PLANNING COMMISSION STAFF REPORT
JUNE 20, 2019

AGENDA ITEM 7.B File No. PL18-0111 – **FIRST STREET APARTMENTS II**

PROJECT SUMMARY: Design Review Permit for the construction of a 50-unit apartment complex

FIGURE 1 APARTMENT RENDERING

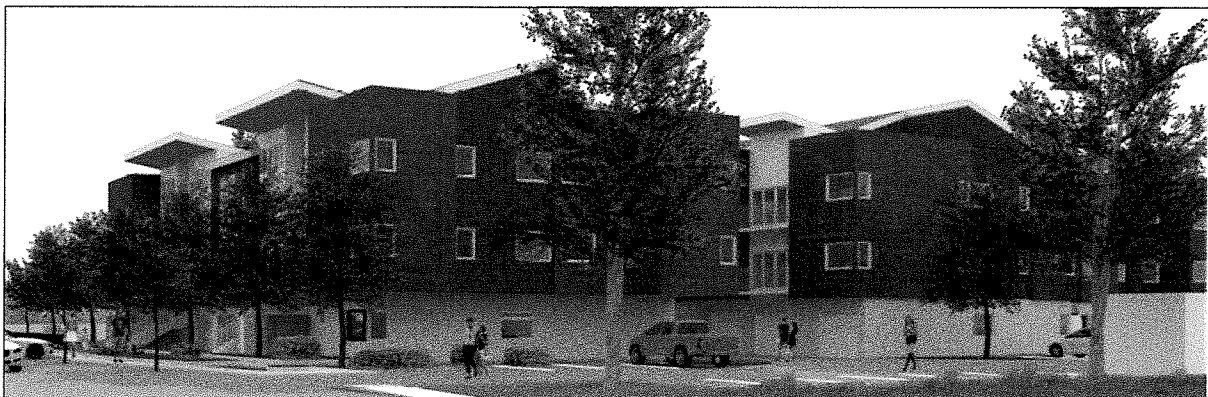
Commission Direction: Provide better representation of the architecture and building materials.

Applicant's Response: The Applicant has provided a cleaner elevations page (Sheet A1.2M and SKAA099 of the project plans, Attachment 3) and has provided separate renderings which give a more realistic depiction of how the building would appear at the site. The plans contain a materials sheet (Sheet A1.2M). An actual materials board will be presented at the Planning Commission meeting.

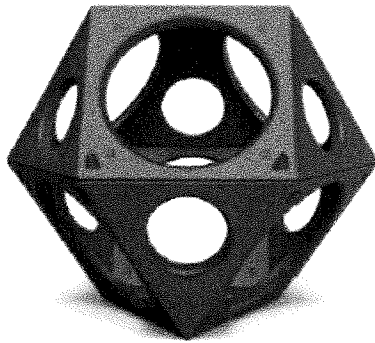
Commission Direction: Provide more outdoor amenities/create a more livable environment.

Applicant's Response: The original site plan contained two (2) seating areas, each containing a bench, a picnic table, and sand box. The revised site plan contains four (4) seating areas, each with a picnic table and bench seat. The two sandboxes remain but the revised plans propose the addition of playground equipment featuring four (4) interconnected "Playworld Playcubes" in one of the open space areas and a "Playworld Challengers" in the other open space area. Three (3) barbeque pits have also been added to three of the seating areas. The overall area containing outdoor amenities has been increased to 11,325 square feet (0.26 acres) from 9,692 square feet (0.11 acres).
